SERVICE BULLETIN

APPLICABILITY: 2018-21MY Crosstrek **NUMBER:** 12-311-21
SUBJECT: Side Cowl Panel Trim- Design Change **DATE:** 02/25/21

COWL PANEL-SIDE

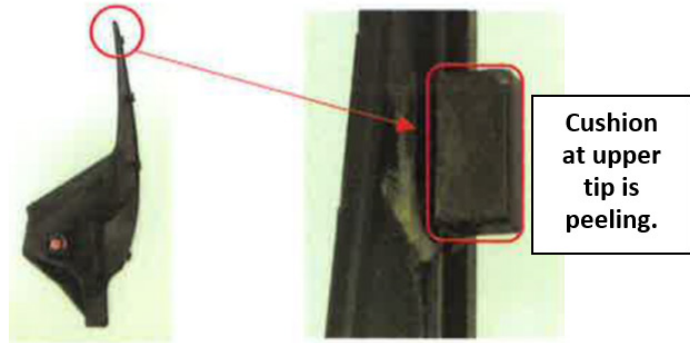
This bulletin announces a design change made to the windshield side cowl panels to address isolated concerns of a buzzing / rattle -type sound heard while driving. The size of the foam cushion portion and the production process to secure it to the part have been optimized to prevent the condition.

The new COWL PANEL-SIDE trims were incorporated into Crosstrek production starting with VIN **MH277078**.

Description	Part Number
COWL PANEL- SIDE, RIGHT	91423FL001
COWL PANEL- SIDE, LEFT	91423FL011
